CITY OF LAVON

ORDINANCE NO. 2013-12-12

AN ORDINANCE OF THE CITY OF LAVON, TEXAS TO PROVIDE FOR THE ADOPTION OF THE 2012 EDITION OF THE INTERNATIONAL RESIDENTIAL CODE AND REGIONAL AMENDMENTS; PROVIDING FOR A REPEAL OF ORDINANCES IN CONFLICT; PROVIDING FOR SEVERABILITY CLAUSE; PROVIDING FOR A PENALTY FOR VIOLATIONS; AND PROVIDING FOR AN EFFECTIVE DATE.

**Recommended Amendments to the
2012 International Residential Code**
North Central Texas Council of Governments region

****Figure R602.6.1; delete the figure and insert the following figure:**

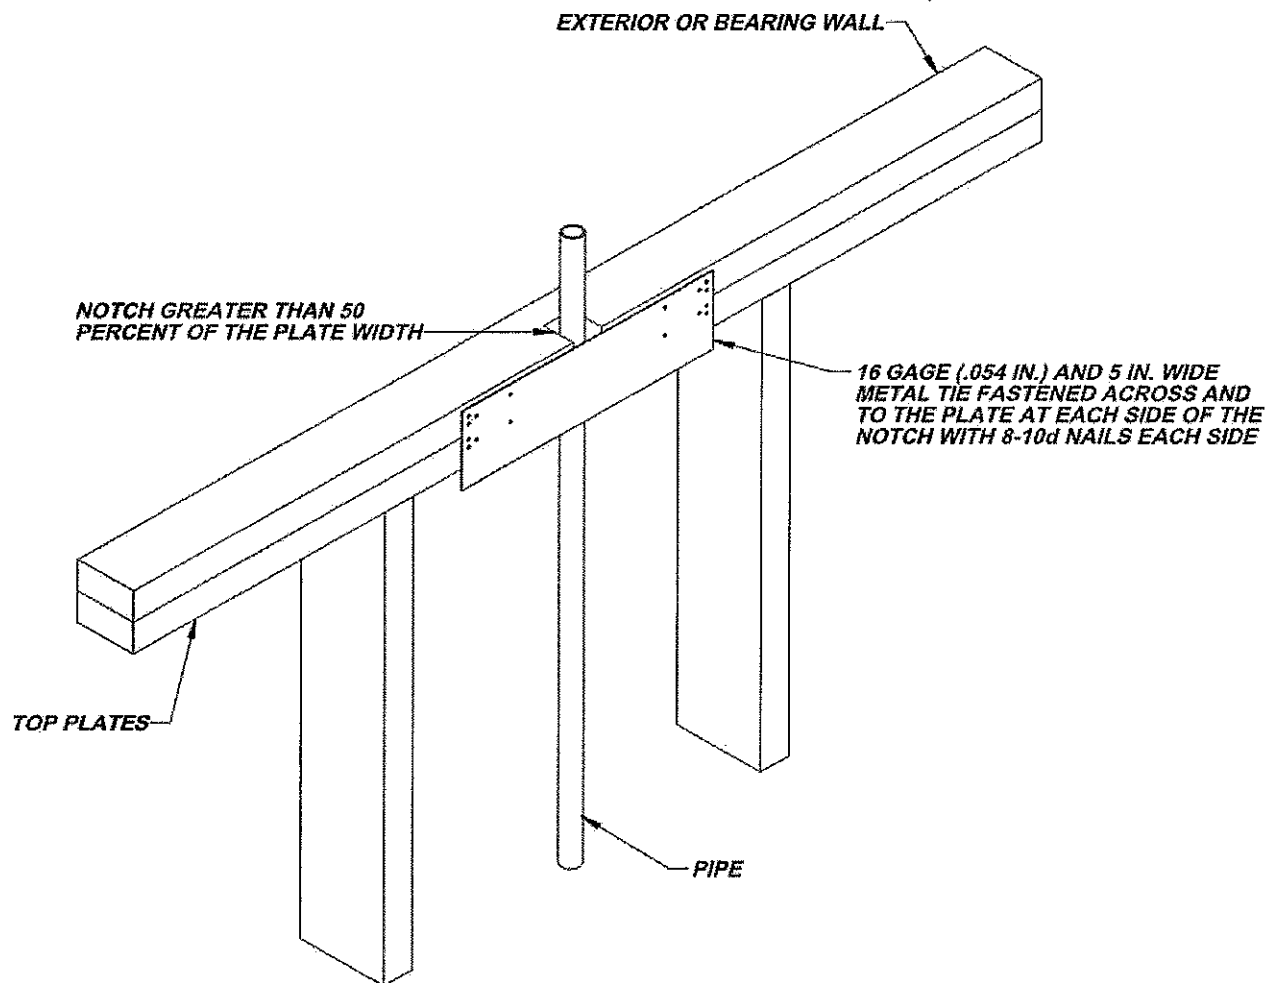
R602.6.1 Drilling and notching of top plate. When piping or ductwork is placed in or partly in an exterior wall or interior load-bearing wall, necessitating cutting, drilling or notching of the top plate by more

than 50 percent of its width, a galvanized metal tie not less than 0.054 inch thick (1.37 mm) (16 Ga) and 4 ½ inches (38) mm 5 inches (127 mm) wide shall be fastened across and to the plate at each side of the opening with not less than eight 10d (0.148 inch diameter) having a minimum length of 1 ½ inches (38 mm) at each side or equivalent. Fasteners will be offset to prevent splitting of the top plate material. The metal tie must extend a minimum of 6 inches past the opening. See figure R602.6.1. {remainder unchanged}

(Reason: reflects regional practice and to comply with P2603.2.1. Also provides additional assurance of maintaining the integrity of the framing by spreading the nailing pattern.)
